PSC April 13, 2015 Inspection Report

INSPECTION REPORT

PERMITTEE - MINE: Coyote Creek Mining Company, L.L.C. - Coyote Creek Mine

PERMITS INSPECTED: NACC-1301 and NACC-1302

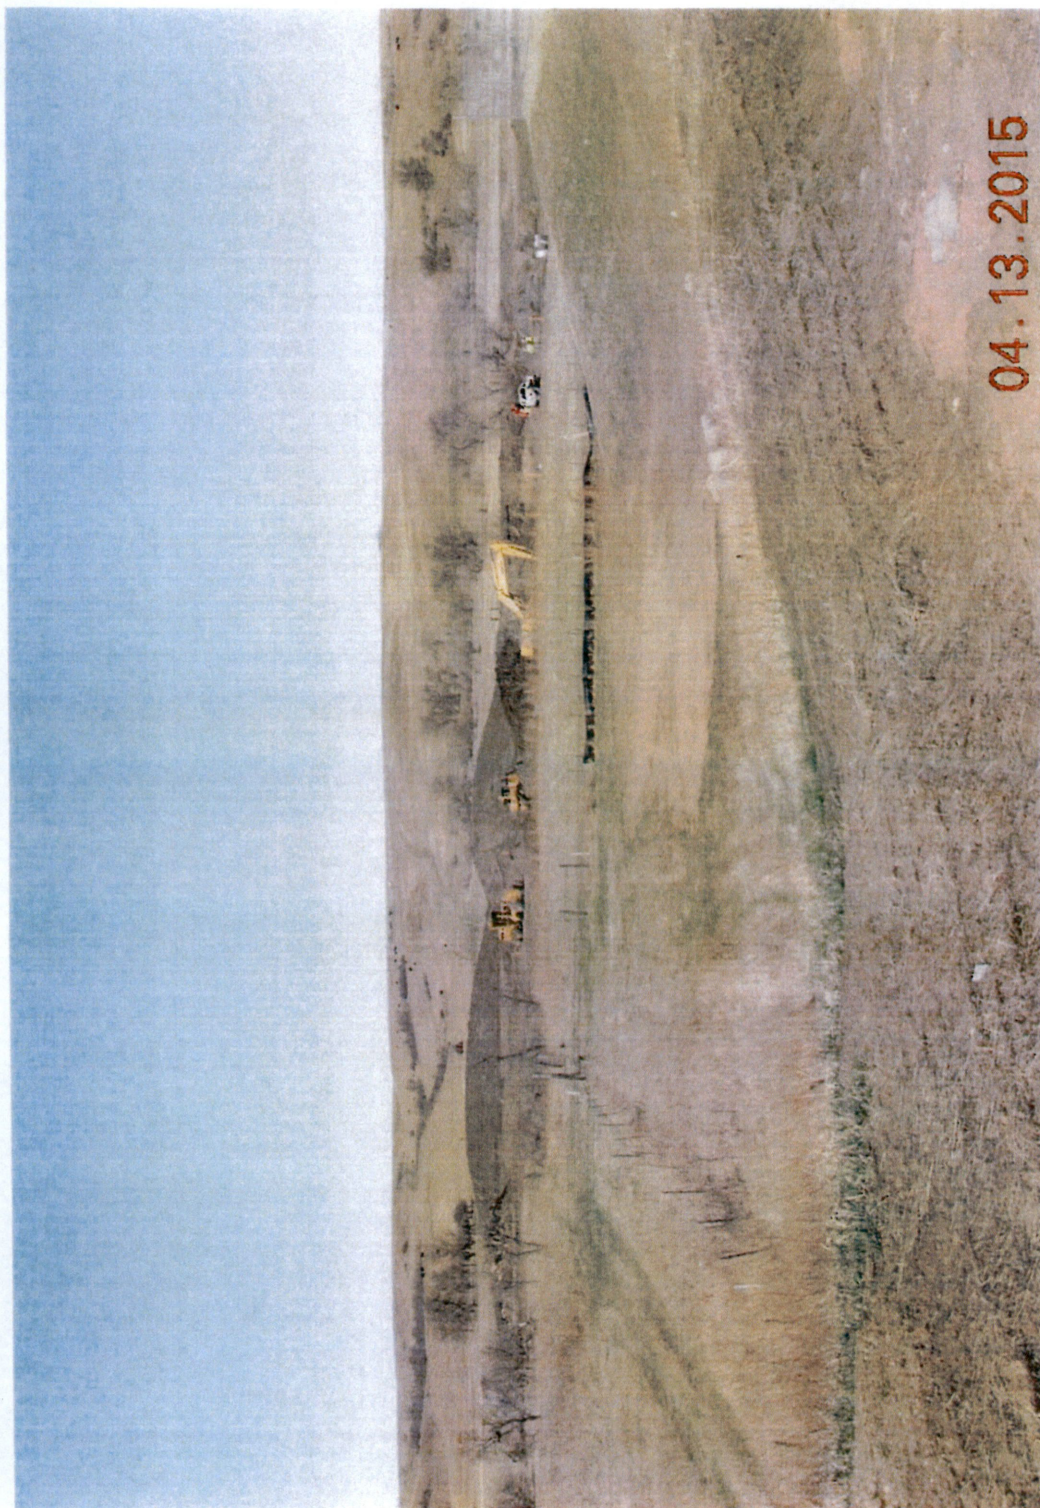
Culvert installation for the Shop Access Road Coyote Creek crossings was also viewed while viewing SPGM removal for a four acre segment of the Shop Access Road on both sides of Coyote Creek as previously described. At the time of inspection, the 36 inch low flow steel culvert was being installed as pictured in Figure 4. It should be noted that the approved design for the 36 inch culvert depicts a slight angle near the culvert's midpoint. The design was revised to depict a straight culvert with the application of Revision No. 1 to Permit NACC-1302 that is under review. The proposed design change was approved by the commission via email correspondence on March 19, 2015 and it received U.S. Army Corps of Engineers concurrence on March 20, 2015. Please refer to Figure 5 for the culvert types and locations for the Shop Access Road Coyote Creek crossings. Installation of the 36 inch low flow steel culvert would need to be completed no later than April 14th because CCMC's Regional General Permit from the U.S. Army Corps of Engineers does not allow regulated activity in Coyote Creek from April 15th to June 1st. Installation of the four 10 foot by 10 foot box culverts will follow but it appears that they will not be installed to divert Coyote Creek flow until after June 1st. Mr. Steffen indicated SPGM removal will proceed westward along the Shop Access Road corridor toward the location for pond P31-01 after the 36 inch low flow steel culvert installation is complete. Overburden from pond P31-01 excavation will provide the fill necessary to achieve grade for the Shop Access Road.

Upon returning to the mine office-shop facility near the close of the inspection the Reclamation Division inspectors informed CCMC personnel that the sequence of Shop Access Road Coyote Creek crossing culvert installations appears to be the reverse order of that approved in Permit NACC-1302. As described in the permit, the culvert crossings would proceed eastward in conjunction with excavation of pond P31-01 with installation of the four 10 foot by 10 foot box culverts first followed by installation of the 36 inch low flow steel culvert. Excerpts from Permit NACC-1302 relevant to the Shop Access Road Coyote Creek crossing culvert installations are as follows:

Based on the foregoing permit excerpts and observations from the April 13, 2015 inspection, it appears that CCMC is conducting operations for the Shop Access Road Coyote Creek culvert installations in reverse order of that approved in Permit NACC-1302. CCMC should have requested commission approval to revise culvert installation plans and provided adequate justification for doing so. Furthermore, it appears that potentially serious environmental risks are posed by installing the low flow culvert prior to diverting Coyote Creek flow through the box culverts. The Coyote Creek stream flow is now restricted through the low flow culvert until the box culverts are installed to divert the stream presumably after June 1st. High stream flow resulting from a heavy precipitation event may overtop the low flow culvert and cut through culvert backfill and the Shop Access Road corridor causing downstream sediment deposition. CCMC is advised to expedite box culvert installation so Coyote Creek flow can be diverted through the box culverts immediately after the U.S. Army Corps of Engineers spring restriction of regulated activity expires. CCMC is also advised to refrain from building any segment of the Shop Access Road near Coyote Creek that could function as an embankment and cause upstream flooding if stream flow is restricted by the low flow culvert.
